PCN – Process Change Notification

Change:	FW.80B.SMA.M
Date:	2017/08/04
Author	Haley Tsai

Model#	Part Number	Changes
Meteor-169MHz Flexible Whip Antenna SMA(M) Straight tuned for the WMB Bracket	FW.80B.SMA.M	<ol style="list-style-type: none"> 1. Amend $\varnothing 4 \pm 0.4\text{mm}$ to $3.7 \pm 0.3\text{mm}$. 2. Amend $\varnothing 61 \pm 0.3\text{mm}$ to $\varnothing 61 \pm 0.6\text{mm}$. 3. Amend $\varnothing 16.05 \pm 0.3\text{mm}$ to $\varnothing 16 \pm 0.6\text{mm}$. 4. Amend cap material from ABS to POM.

Illustration of Change Old drawing

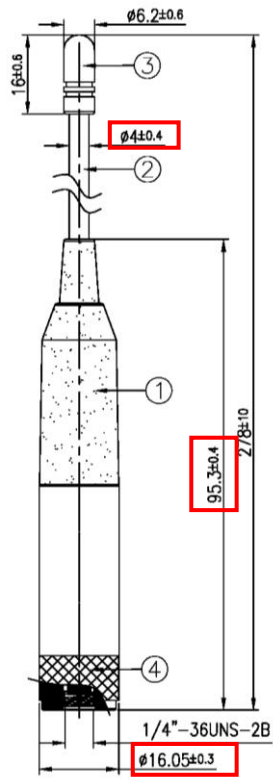
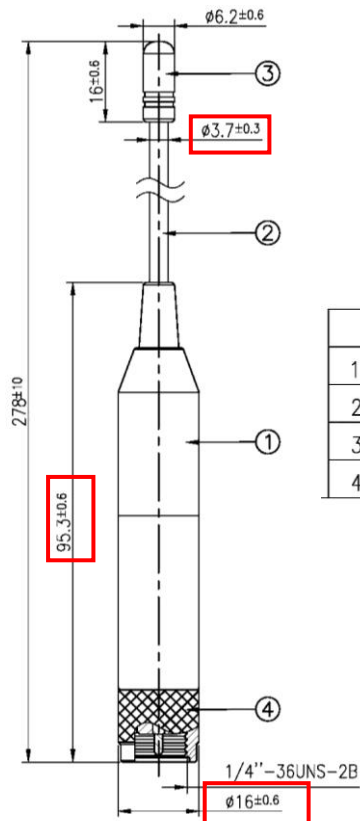
1. Amend $\varnothing 4 \pm 0.4\text{mm}$ to $3.7 \pm 0.3\text{mm}$.
2. Amend $\varnothing 61 \pm 0.3\text{mm}$ to $\varnothing 61 \pm 0.6\text{mm}$.
3. Amend $\varnothing 16.05 \pm 0.3\text{mm}$ to $\varnothing 16 \pm 0.6\text{mm}$.
4. Amend cap material from ABS to POM.
